This Value Engineering report summarizes the results of the Value Engineering study performed by Ventry Engineering for the Kentucky Transportation Cabinet. The study was performed during the week of February 2-6, 1998.

The subject of the study was the I-75 Widening from KY 36 to KY 491 (Williamstown to Crittenden).

**NORMAL SECTION
NORTH BOUND I-75**

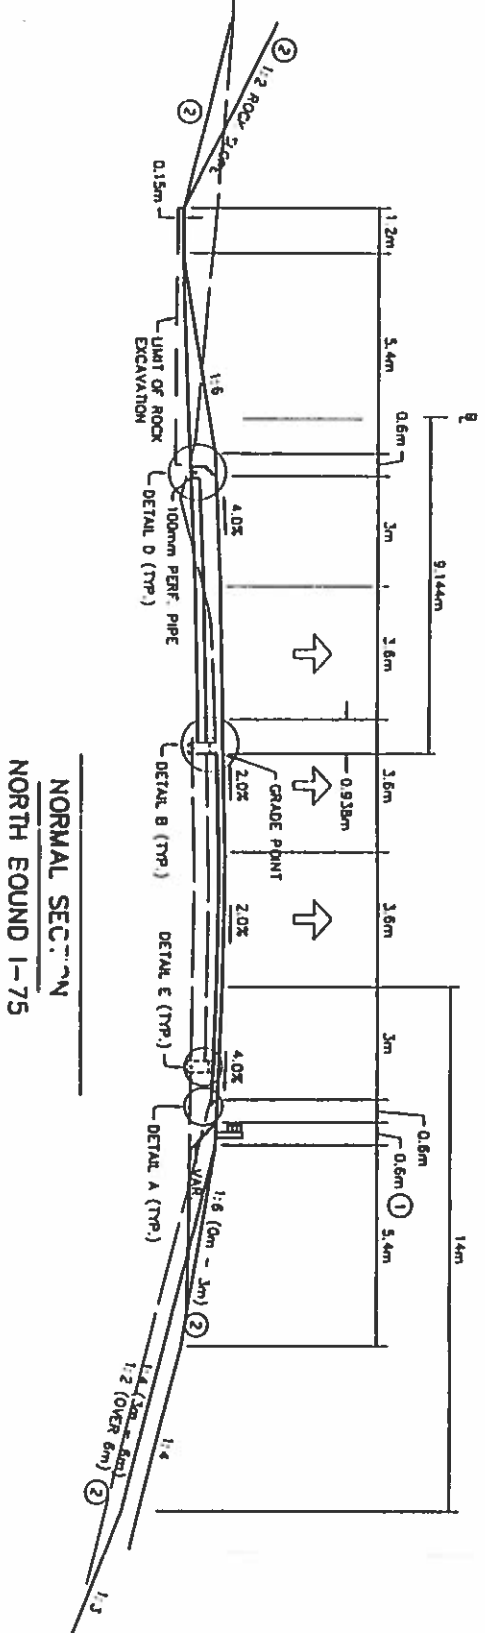
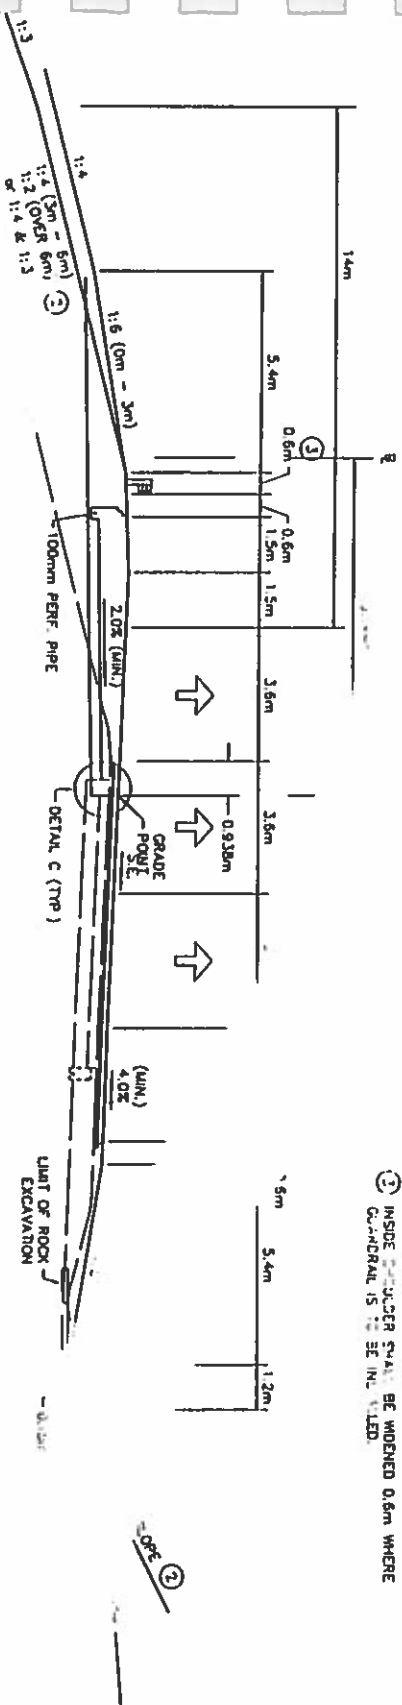
As shown in the typical section detail (Details B, C, & D), a 25mm modified open graded wearing course is to be placed on the bituminous base course. In discussions during the value engineering study, it was indicated that the function of the wearing course is to prevent raveling of the base course and also provide a desirable pavement surface while traffic is being maintained during the stage construction of the pavement section.

The Value Engineering Team concluded that the open graded wearing course should be eliminated since the base course should provide an adequate pavement surface for the temporary maintenance of traffic while the pavement section is being stage constructed. If the base course has a history of raveling, a binder course might be desirable which would be more cost effective than the open graded wearing course.

**TYPICAL ASPHALT OVERLAY DIMENSIONS
DETAIL "3A"**

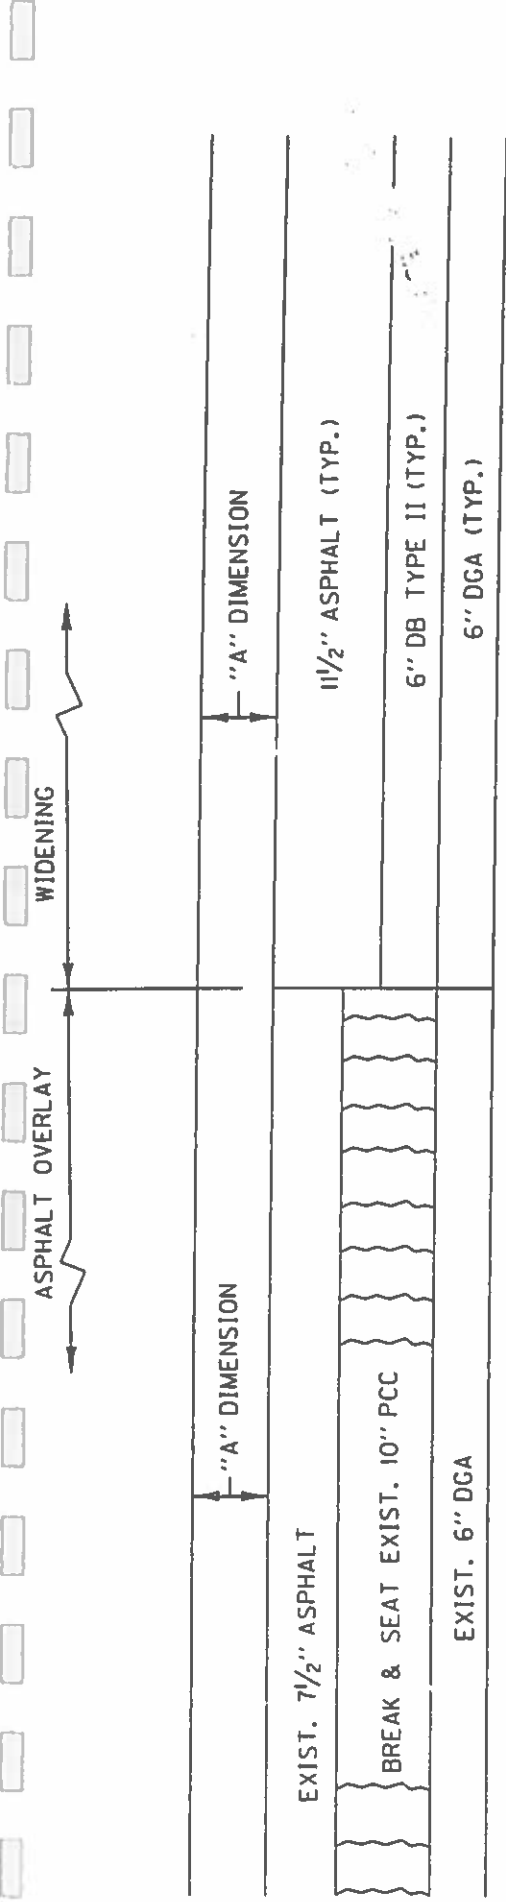
As shown in the pavement structure sketch (Detail 3A), the proposed overlay thickness, ("A" Dimension), is 6.5 inches, which is adequate for 50×10^6 ESALS and a CBR of 2. Since the projected design year ESALS for this projects (see ESAL computations) exceed 30×10^6 , the Value Engineering team concluded that the required overlay thickness should be based on 50×10^6 , particularly in view of the fact that only an additional 1/2" of pavement thickness is required to provide the necessary pavement structural support for the 50×10^6 vs 30×10^6 ESAL requirements. The Value Engineering team was advised that a CBR value of 2 is appropriate for the existing general subgrade conditions on this project.

Also shown on the pavement structure sketch, (Detail 3A) is the proposed pavement thickness for the pavement widening which calls for a total bituminous base and surface thickness of 18 inches (11 1/2" + 6 1/2"). Since the SN value for the proposed widened section as shown in the tabulation is 9.36 vs a required SN value of 8.26, the Value Engineering Team considered alternative pavement thicknesses that would provide the required SN value by varying the different pavement thicknesses, such as increasing the depth of the less expensive drainage blanket material and decreasing the thickness of the more expensive bituminous base material.

"As Proposed" Fill Slope Configuration

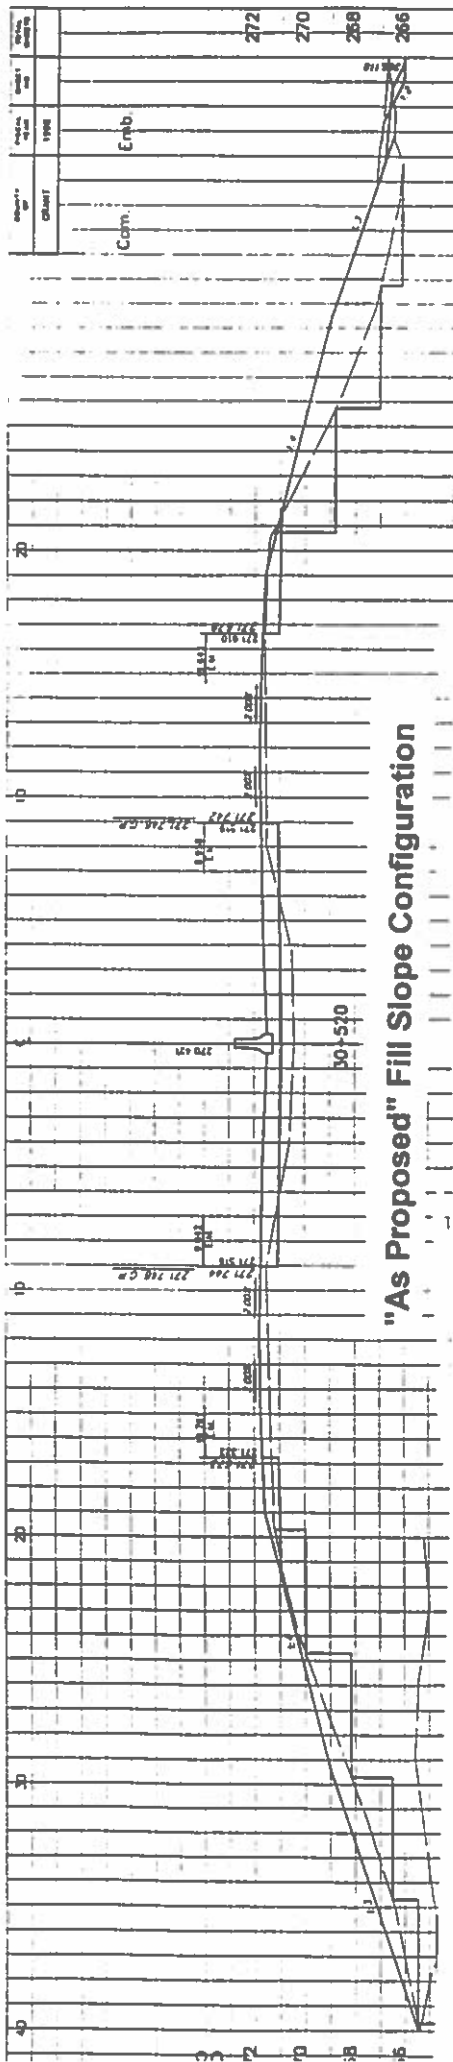
The "As Proposed" design flattens existing fill slopes to 1:4 & 1:3 so as to eliminate existing guardrail. The "As Proposed" also lays back steep cut slopes to 1:2 to minimize maintenance required to keep falling rocks out of the clear zone. Additional R/W will be required to accommodate these new flatter slopes in some areas.

Barnes Pike
VE A.I.T.

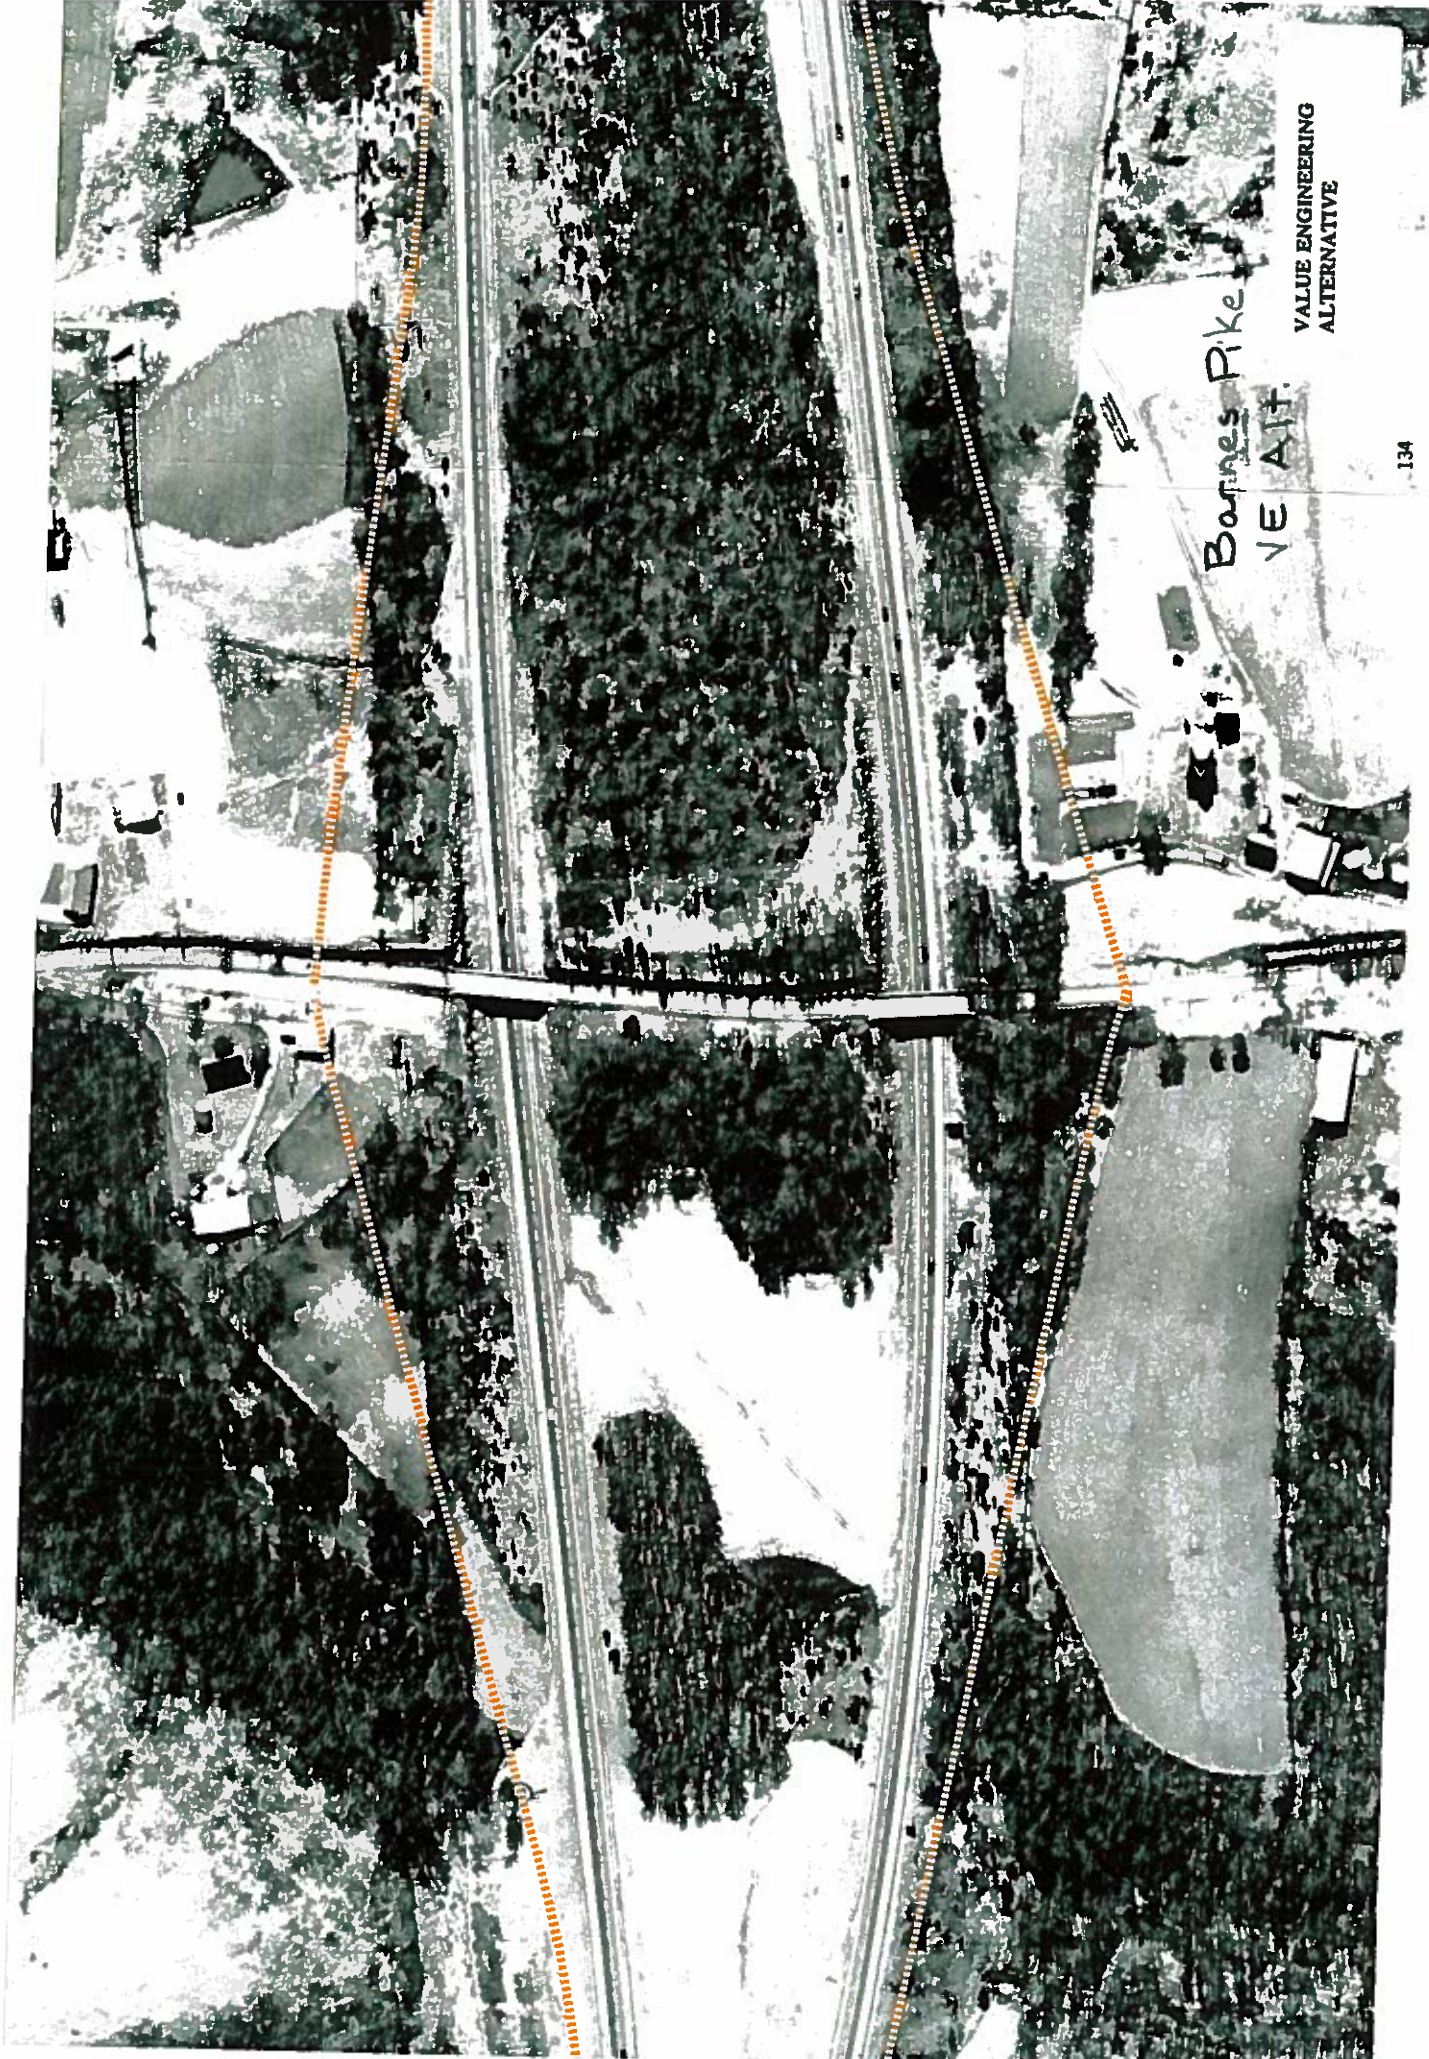
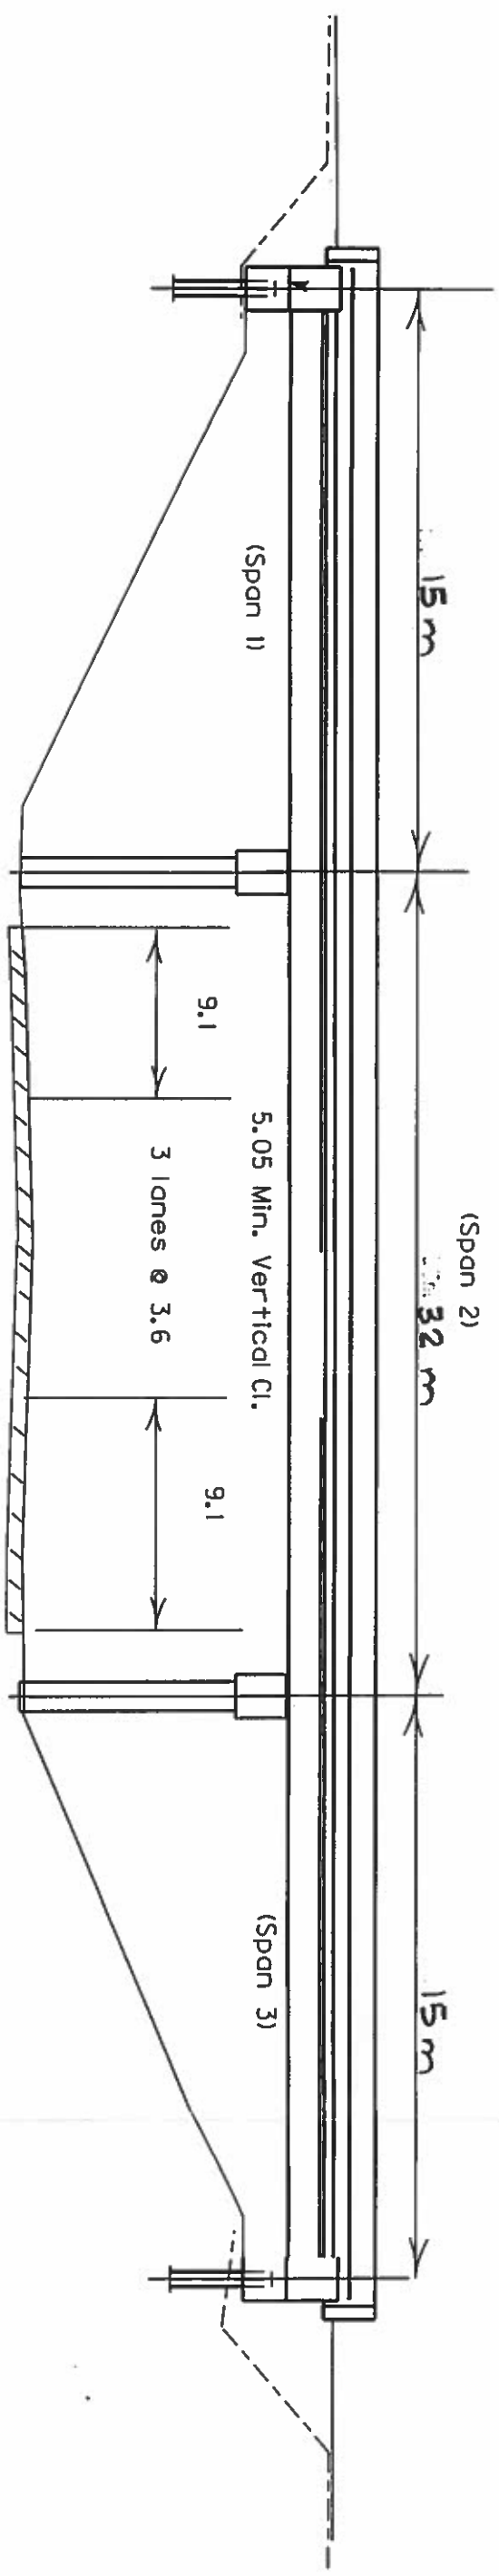
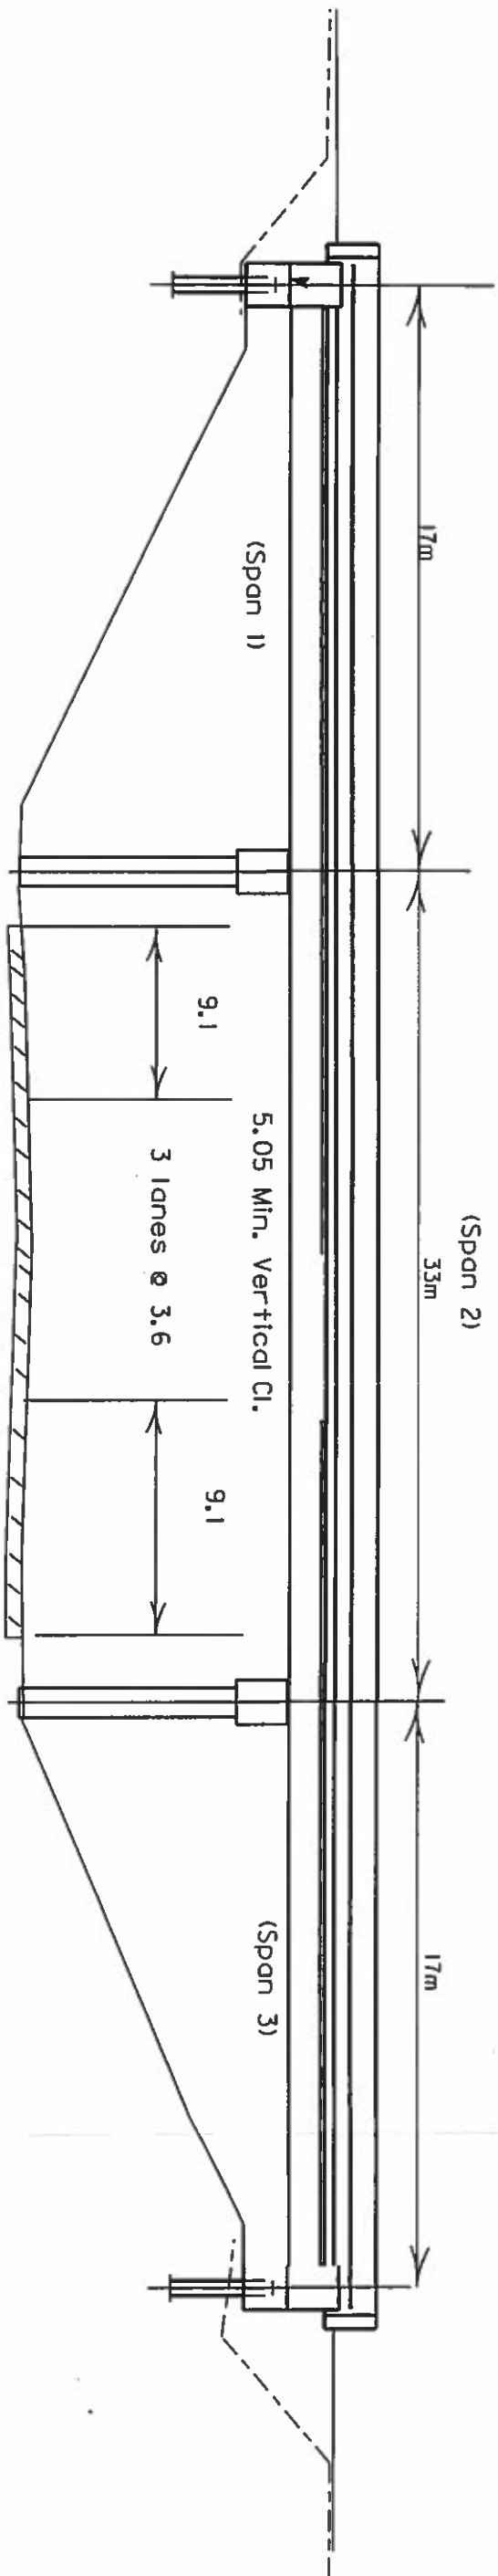
The Value Engineering Alternative utilizes the "As Proposed" diamond interchange with two new bridges. The new bridges will be built at the location of the existing bridges. Acrow temporary bridges owned by the Transportation Cabinet can be used for MOT. The interchange ramps will be built before the bridges. This allows the ramps to be used for MOT during critical stages of existing bridge demolition and new bridge construction. Also, this alternative does not require realignment of Barnes Pike.
